Exhibit 1: Brooks Atkinson Theater

Exhibit 1B: Architectural Modifications

Exh. 1B Architectural Modifications to Brooks Atkinson Theater

**2. GERSHWIN THEATER
4TH FLOOR SOUTH - WOMEN MULTI-USER TOILET ROOM PLAN**

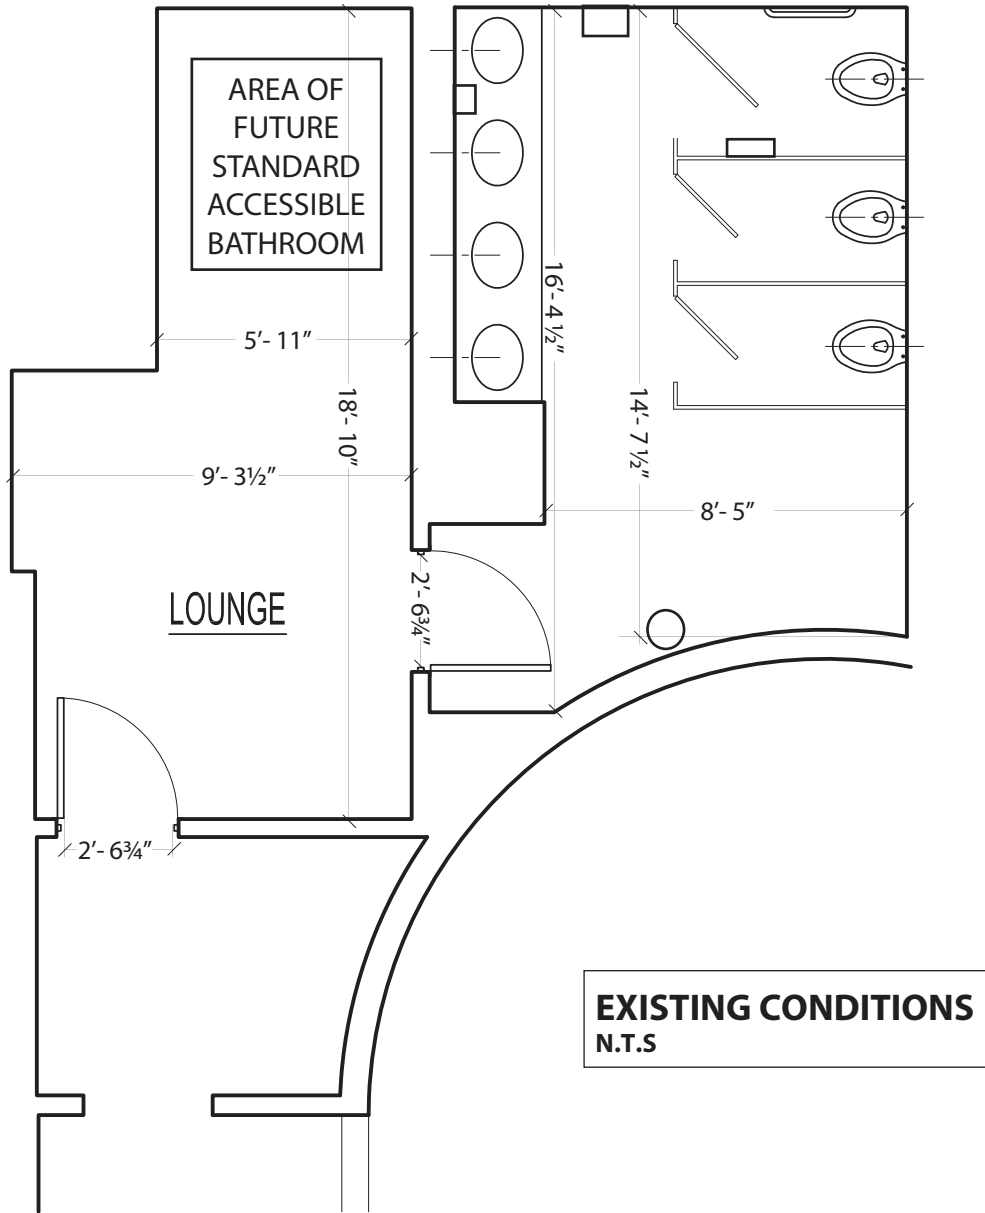
23	Fourth Level (Women's Multi-user Toilet Room, South)	The main entry door is 34" wide and provides 31" clear width.	Remove existing door, widen opening, and install new door that provides the minimum required clear width. Coordinate with maneuvering clearance requirements.	4.1.3(7)(c) 4.13.5 Fig. 24 4.13.9 4.13.10	Defendant will provide a compliant door.
24	Fourth Level (Women's Multi-user Toilet Room, South)	The door from the lounge to the toilet room is 34" wide and provides 31" clear width.	Remove existing door, widen opening, and install new door that provides the minimum required clear width. Coordinate with maneuvering clearance requirements.	4.1.3(7)(c) 4.13.5 Fig. 24 4.13.9 4.13.10 4.13.11	Defendant will provide a compliant women's standard accessible bathroom on fourth level South adjacent to lounge entrance to women's room on fourth level South.
25	Fourth Level (Women's Multi-user Toilet Room, South)	Door hardware requires tight grasping, pinching, and/or twisting of the wrist to operate.	Remove existing operating hardware and install compliant hardware.	4.1.3(7)(c) 4.13.9	Defendant will provide a compliant women's standard accessible bathroom on fourth level South adjacent to lounge entrance to women's room on fourth level South.

28	Fourth Level (Women's Multi-user Toilet Room, South)	The wall sconce protrudes into the circulation path 9" at 53" AFF.	Raise wall sconce to greater than 80" AFF without altering fixture.	4.4.1 Fig. 8 (a-e)	Defendant will provide a compliant women's standard accessible bathroom on fourth level South adjacent to lounge entrance to women's room on fourth level South.
29	Fourth Level (Women's Multi-user Toilet Room, South)	The side grab bar is 28.25" AFF, mounted 17" from the rear wall, and is 24" long.	Remove existing side grab bar and install new compliant side grab bar. Ensure that grab bar is mounted 12" maximum from rear wall and extends at least 54" from rear wall (or 52" if in stall).	4.1.3(11) 4.22.4 4.17.6 4.26 Fig.30	Defendant will provide a compliant women's standard accessible bathroom on fourth level South adjacent to lounge entrance to women's room on fourth level South.
30	Fourth Level (Women's Multi-user Toilet Room, South)	Knee space at the counter mounted lavatories is 26.25" AFF.	Remove the existing lavatory and counter. Install a new compliant counter and reinstall the existing lavatory. Repair/refinish wall as needed.	4.1.3(11) 4.22.6 4.19.2 Fig. 31	Defendant will provide a compliant women's standard accessible bathroom on fourth level South adjacent to lounge entrance to women's room on fourth level South.

38	Fourth Level (Women's Multi-user Toilet Room, South)	There is no rear grab bar.	Install new compliant rear grab bar. Provide backing in wall as necessary.	4.17.6 Fig. 29, Fig.30	Defendant will provide a compliant women's standard accessible bathroom on fourth level South adjacent to lounge entrance to women's room on fourth level South.
39	Fourth Level (Women's Multi-user Toilet Room, South)	The water closet seat height is 15" AFF and it is mounted 21.5" to centerline from the side wall.	Floor-mounted water closet: replace existing water closet with compliant water closet with seat installed 17"-19" AFF and 18" centerline to side wall. Adapt flush control as needed.	4.16.3 Fig. 29(b) 4.16.2 4.17.3 Fig. 28, Fig. 30	Defendant will provide a compliant women's standard accessible bathroom on fourth level South adjacent to lounge entrance to women's room on fourth level South.
40	Fourth Level (Women's Multi-user Toilet Room, South)	The paper towel dispenser is mounted at 58" AFF.	Install new towel dispenser within reach range where required clear floor space is available. Existing noncompliant towel dispenser may remain.	4.1.3(11) 4.22.7 4.27.3	Defendant will provide a compliant women's standard accessible bathroom on fourth level South adjacent to lounge entrance to women's room on fourth level South.

**2. GERSHWIN THEATER
4TH FLOOR NORTH - WOMEN MULTI-USER TOILET ROOM PLAN**

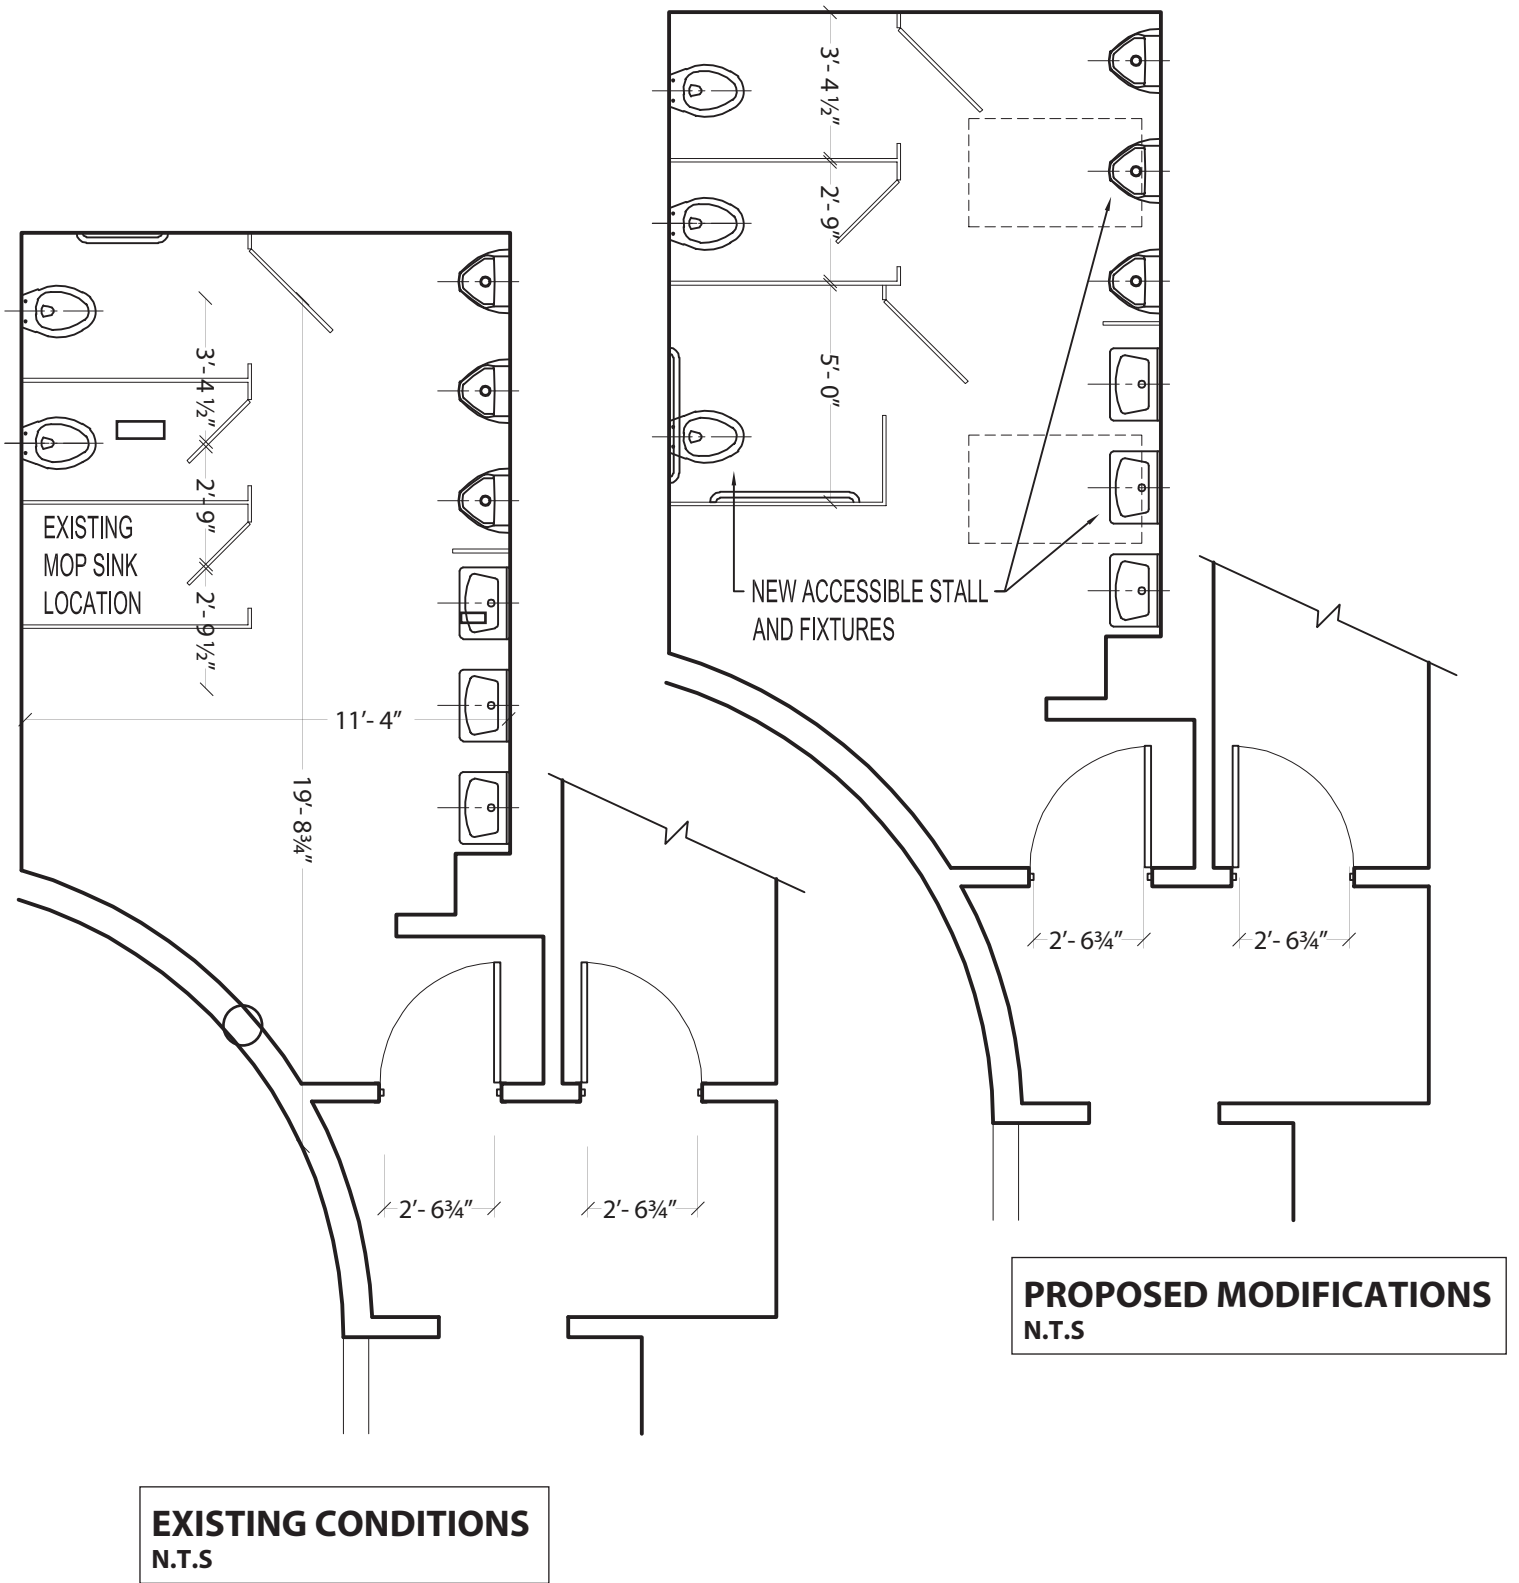
8	Fourth Level (Women's Multi-user Toilet Room, North)	The main entry door is 34" wide and provides 31" clear width.	Remove existing door, widen opening, and install new door that provides the minimum required clear width. Coordinate with maneuvering clearance requirements.	4.1.3(7)(c) 4.13.5 Fig. 24	Defendant will provide compliant door.
9	Fourth Level (Women's Multi-user Toilet Room, North)	Door hardware requires tight grasping, pinching, and/or twisting of the wrist to operate.	Remove existing operating hardware and install compliant hardware.	4.1.3(7)(c) 4.13.9	Defendant will provide compliant hardware.
10	Fourth Level (Women's Multi-user Toilet Room, North)	Door hardware requires tight grasping, pinching, and/or twisting of the wrist to operate.	Remove existing operating hardware and install compliant hardware.	4.1.3(7)(c) 4.13.9	Defendant will provide a compliant women's standard accessible bathroom on fourth level North, adjacent to lounge entrance to women's room on fourth level North.

Line #	Location Description	Existing Condition	Barrier Description	1991 Standards Reference	Architectural Modification
11	Fourth Level (Women's Multi-user Toilet Room, North)	The pull side maneuvering clearance width is 6.5".	Alter existing walls and/or relocate existing door and frame to obtain required maneuvering clearances.	4.13.6 Fig. 25(a-f)	Defendant will provide a compliant women's standard accessible bathroom on fourth level North, adjacent to lounge entrance to women's room on fourth level North.
12	Fourth Level (Women's Multi-user Toilet Room, North)	The wall sconce protrudes into the circulation path 9.25" at 62.5" AFF.	Raise wall sconce to greater than 80" AFF without altering fixture.	4.4.1 Fig.8(a-e)	Defendant will provide a compliant women's standard accessible bathroom on fourth level North, adjacent to lounge entrance to women's room on fourth level North.
13	Fourth Level (Women's Multi-user Toilet Room, North)	Knee space at the counter mounted lavatories is 26" AFF at the front edge.	Remove the existing lavatory and counter. Install a new compliant counter and reinstall the existing lavatory. Repair/refinish wall as needed.	4.1.3(11) 4.22.6 4.19.2 Fig. 31	Defendant will provide a compliant women's standard accessible bathroom on fourth level North, adjacent to lounge entrance to women's room on fourth level North.

Line #	Location Description	Existing Condition	Barrier Description	1991 Standards Reference	Architectural Modification
16	Fourth Level (Women's Multi-user Toilet Room, North)	The threshold at the door from the lounge to the toilet room has a 1/2" vertical rise and is unbeveled on the toilet room side of the threshold.	Remove the existing threshold and install a compliant threshold.	4.1.3(7)(c) 4.1.6(3)(d)(ii) 4.13.8 4.5.2 Fig.7(c,d)	Defendant will provide a compliant women's standard accessible bathroom on fourth level North, adjacent to lounge entrance to women's room on fourth level North.
17	Fourth Level (Women's Multi-user Toilet Room, North)	The toilet paper dispenser is mounted 41.25" from the rear wall on the side opposite the side grab bar.	Relocate existing compliant toilet paper dispenser as required, ensuring 1 1/2" clearance below grab bar. Repair/refinish wall or partition as needed.	4.16.6 Fig. 29(b) Fig. 30(d)	Defendant will provide a compliant women's standard accessible bathroom on fourth level North, adjacent to lounge entrance to women's room on fourth level North.

20	Fourth Level (Women's Multi-user Toilet Room, North)	There is no rear grab bar.	Install new compliant rear grab bar. Provide backing in wall as necessary.	4.17.6 Fig. 29 Fig. 30	Defendant will provide a compliant women's standard accessible bathroom on fourth level North, adjacent to lounge entrance to women's room on fourth level North.

Line #	Location Description	Existing Condition	Barrier Description	1991 Standards Reference	Architectural Modification
21	Fourth Level (Women's Multi-user Toilet Room, North)	The water closet seat height is 19.25" AFF and it is mounted 19.75" to centerline from the side wall.	Floor-mounted water closet: replace existing water closet with compliant water closet with seat installed 17"-19" AFF and 18" centerline to side wall. Adapt flush control as needed.	4.16.3 Fig. 29(b) 4.16.2 4.17.3 Fig. 28 Fig.30	Defendant will provide a compliant women's standard accessible bathroom on fourth level North, adjacent to lounge entrance to women's room on fourth level North.
22	Fourth Level (Women's Multi-user Toilet Room, North)	The paper towel dispenser is mounted at 56.5" AFF.	Install new towel dispenser within reach range where required clear floor space is available. Existing noncompliant towel dispenser may remain.	4.1.3(11) 4.22.7 4.27.3	Defendant will provide a compliant women's standard accessible bathroom on fourth level North, adjacent to lounge entrance to women's room on fourth level North.

**3. LUNT FONTANNE THEATER
LOWER LEVEL MEN TOILET ROOM PLAN**

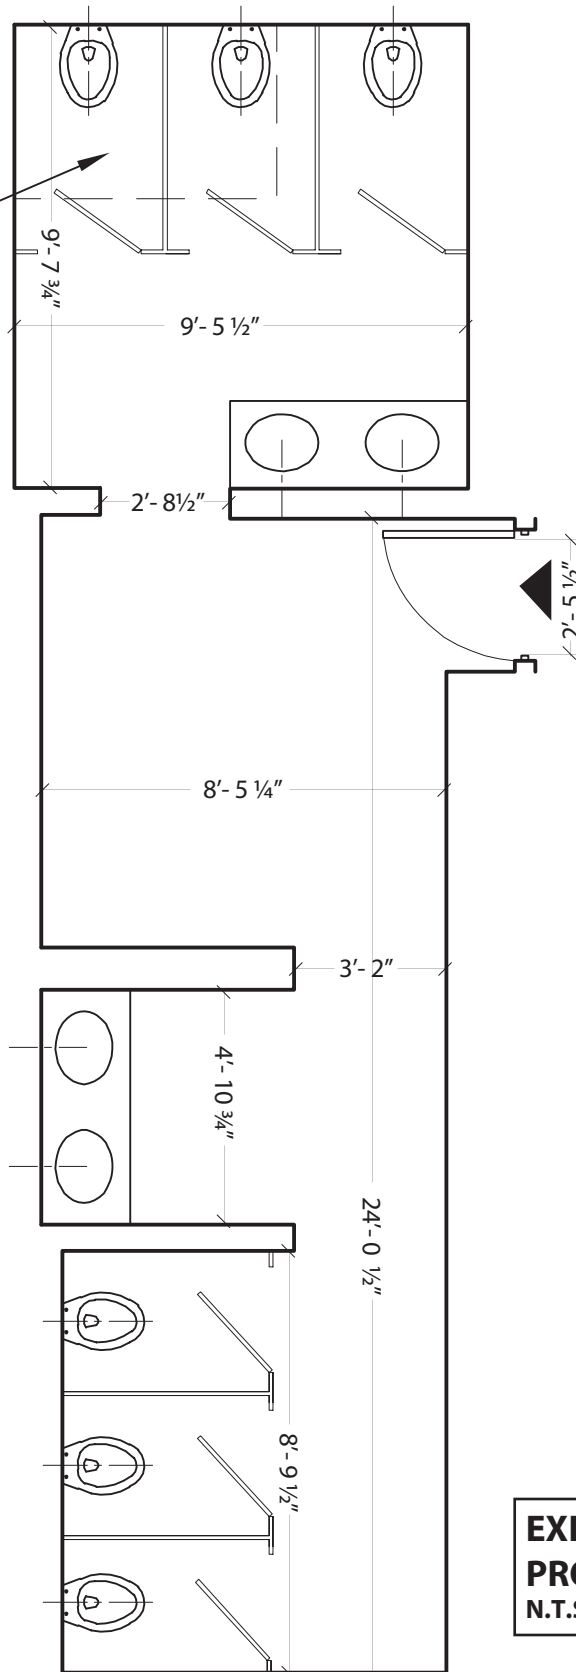
MODIFY PARTITION
TO OBTAIN
AMBULATORY STALL
(OUT-SWINGING
DOOR, GRAB BARS
BOTH SIDE)

21	Lower Level (Men's Toilet Room)	The door is located in an alcove 11" deep with 3" width maneuvering clearance on the pull side of the door.	Maneuvering clearance at doorway is less than required.	4.1.3(7)(b) 4.1.3(7)(c) 4.1.3(7)(d) 4.13.6 Fig. 25(a-f)	Defendant will modify doorway to provide compliant maneuvering clearance.
22	Lower Level (Men's Toilet Room)	There are 4 lavatories with 32" rim height with no knee space provided.	The counter mounted lavatory provides less than the required knee clearance (29" minimum AFF at front, 27" minimum AFF at 8" deep).	4.1.3(11) 4.19.2 4.19.3 4.22.6 Fig. 31	Compliant lavatory has been provided during course of investigation.

Line #	Location Description	Existing Condition	Barrier Description	1991 Standards Reference	Architectural Modification
23	Lower Level (Men's Toilet Room)	The toilet paper dispenser is mounted 32" to the near edge from the rear wall and 42" to the far edge from the rear wall.	The toilet paper dispenser in the standard accessible stall is mounted more than 36" from the rear wall.	4.1.3(11) 4.1.6(1)(b) 4.1.6(2) 4.16.6 4.22.4 4.22.7 Fig. 29(b) Fig. 30(d)	Compliant toilet dispenser mounting location has been provided during course of investigation.
24	Lower Level (Men's Toilet Room)	There is no rear grab bar in the accessible stall.	There is no rear grab bar in the accessible stall.	4.1.3(11) 4.1.6(1)(b) 4.1.6(1)(c) 4.1.6(1)(k)(ii) 4.1.6(2) 4.17.6 4.22.4 Fig. 29 Fig. 30(a,a-1)	Defendant will provide compliant rear grab bar.
25	Lower Level (Men's Toilet Room)	There is no coat hook in the accessible toilet stall although one of the three non-accessible stalls has a coat hook.	There is no coat hook in the accessible toilet stall.	36.202(b) 4.1.3(11) 4.2.5 4.2.6 4.22.7 4.25 4.27.3 Fig. 5 Fig. 6 Fig.38	Compliant coat hook mounting height has been provided during course of investigation.

**3. LUNT FONTANNE THEATER
ORCHESTRA LEVEL ACCESSIBLE TOILET ROOM
AND BOX OFFICE PLANS**

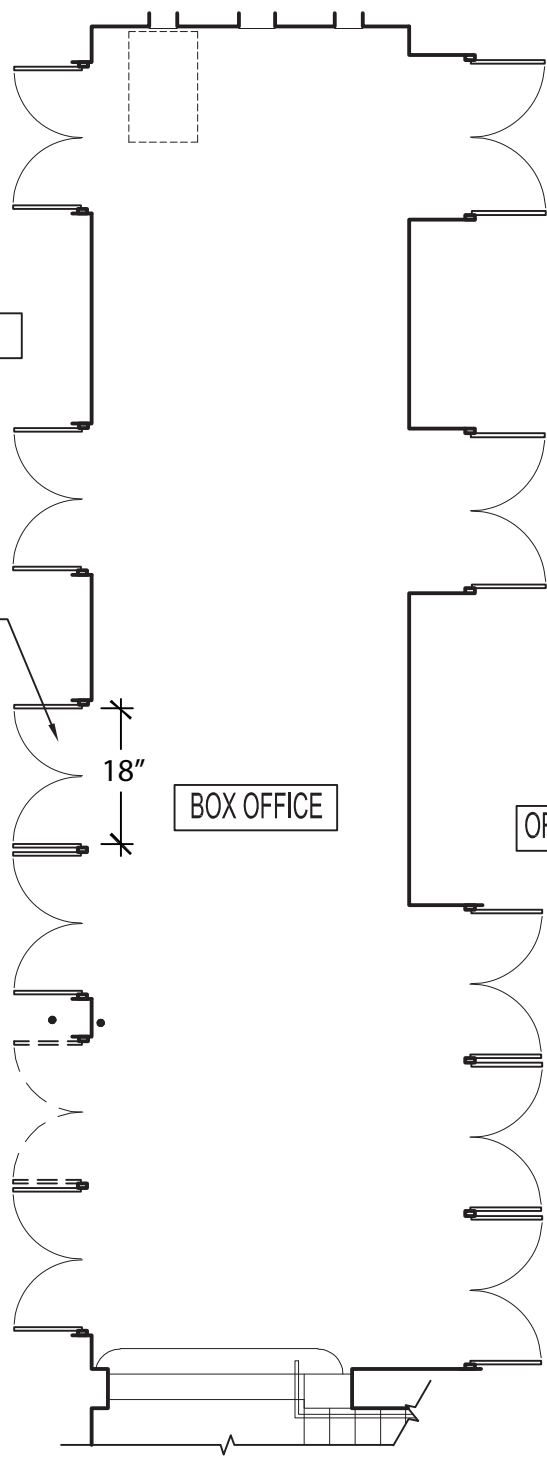
Line #	Location Description	Existing Condition	Barrier Description	1991 Standards Reference	Architectural Modification
5	Box Office	There are 6 pairs of 33" wide wooden doors that provide 28½" - 29" of clear width.	Clearance widths of paired exterior entry doors are less than 32" per active leaf.	4.1.3(7) 4.13.4 4.13.5 Fig. 24	Modifications to the wooden doors are technically infeasible to structural constraints, means of egress widths and landmark status designation. However, defendant will continue to provide automatic doors at the first set of double doors from the ticket window, where the slope is less steep.
6	Box Office	There are 5 pairs of 34" wide wooden doors that provide 31" of clear width.	Clearance widths of paired doors into theatre are less than 32" per active leaf.	4.1.3(7)(b) 4.1.3(7)(c) 4.1.3(7)(d) 4.13.4 4.13.5 Fig. 24	Modifications to the wooden doors are technically infeasible to structural constraints, means of egress widths and landmark status designation. However, defendant will continue to provide automatic doors at the first set of double doors from the ticket window, where the slope is less steep.

7	Box Office	The doors from the Box Office into the Theatre have a 4% slope within the maneuvering clearances.	Floor surface within required area for door maneuvering clearance is not level.	4.1.3(1) 4.1.3(7)(b) 4.1.3(7)(c) 4.1.3(7)(d) 4.3.9 4.13.6 Fig. 25	Defendant shall provide automatic doors at the first set of double doors from the ticket window, where the slope is less steep.

Line #	Location Description	Existing Condition	Barrier Description	1991 Standards Reference	Architectural Modification
8	Box Office	The ¾" thresholds are beveled 1:2 and there is a ¾" vertical rise from the threshold to the top of the carpet for a total of 1 1/2" rise at the doors.	Existing threshold is greater than ½" high.	4.1.3(7)(b) 4.1.3(7)(c) 4.1.3(7)(d) 4.1.6(3)(d)(ii) 4.13.8 4.5.2 Fig. 7(c,d)	Defendant will lower threshold to compliant height.
9	Lower Level - (Back of Theatre)	The concession countertops are 42" AFF.	Sales, service, or information counter is higher than 36" AFF at cash register(s) for sales or distribution of goods or services to the public.	7.2(1) 7.2(2) 4.3	Compliant concession countertops have been provided during course of investigation.
10	Lower Level (Women's Toilet Room)	Overhead sign but no compliant RLB sign provided.	There is no raised lettering and Braille room identification sign provided at this gender specific multi- user toilet room.	4.1.3(16)(a) 4.30.1 4.30.4 4.30.5 4.30.6	Compliant signage will be provided.

**5. MINSKOFF THEATER
ORCHESTRA LEVEL HOUSE RIGHT - WOMEN TOILET ROOM PLAN**

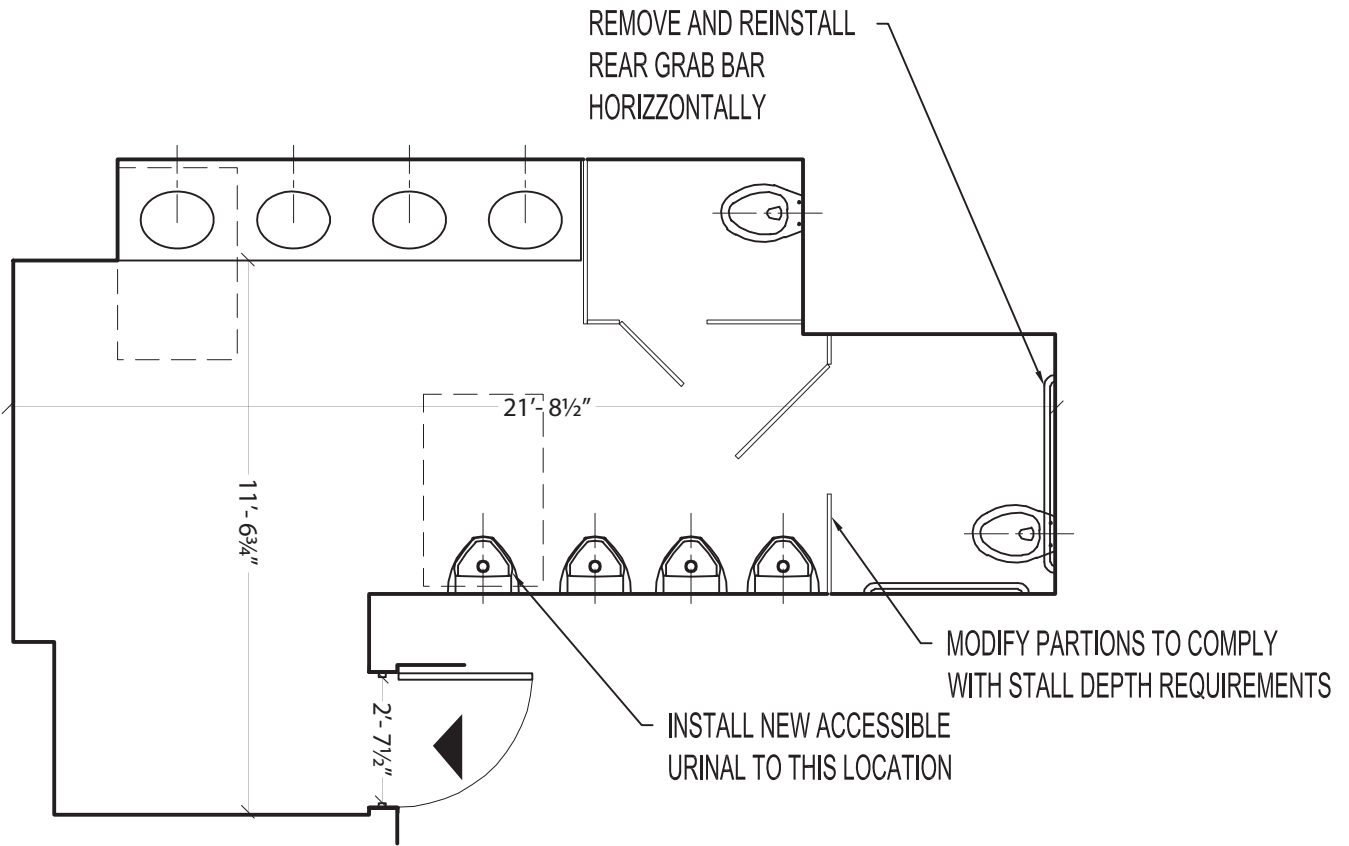
Line #	Location Description	Existing Condition	Barrier Removal	1991 Standards Reference	Architectural Modification
42	Orchestra Level House Right (Women's Toilet Room)	The side grab bar is 7" from the rear wall and extends 50" from the rear wall.	Remove the otherwise compliant grab bar and reinstall it in the required location.	4.1.3(11) 4.22.4 4.17.6 Fig. 30 4.26	Defendant will install compliant grab bar.
43	Orchestra Level House Right (Women's Toilet Room)	There is no raised lettering and Braille room identification sign provided at this gender specific multi-user toilet room.	Install compliant (includes raised lettering and Braille) room identification signage adjacent to strike side of door at 60" AFF to centerline. Coordinate with requirement for close approach without encountering protruding object or door swing.	4.1.3(16)(a) 4.30.1 4.30.4 4.30.5 4.30.6	Defendant will provide compliant signage.

44	Orchestra Level House Right (Women's Toilet Room)	The door at this toilet room is 34" wide and provides 31" of clear width at 90° open.	Remove the existing door, widen opening and install a new door that provides the minimum required clear width. Coordinate with maneuvering clearance requirements.	4.1.3(7)(c) 4.13.5 Fig. 24	Defendant will install accessible door.
45	Orchestra Level (House Right Lobby)	The underside of the escalator and stairs provide less than 80" of clear head room.	Construct a cane-detectable warning which notifies blind or vision-impaired persons of hazard.	4.1.3(2) 4.4.2 Fig.8(a) Fig.8(c-1)	Defendant will install cane detectable warning.
46	Orchestra Level (House Right Lobby)	The concession stand counter is at 43" AFF.	Alter at least 1 counter of each type such that a section at least 36" long is not higher than 36" AFF and is on an accessible route.	7.2(1) 4.3	Operating concession stands will include accessible section.
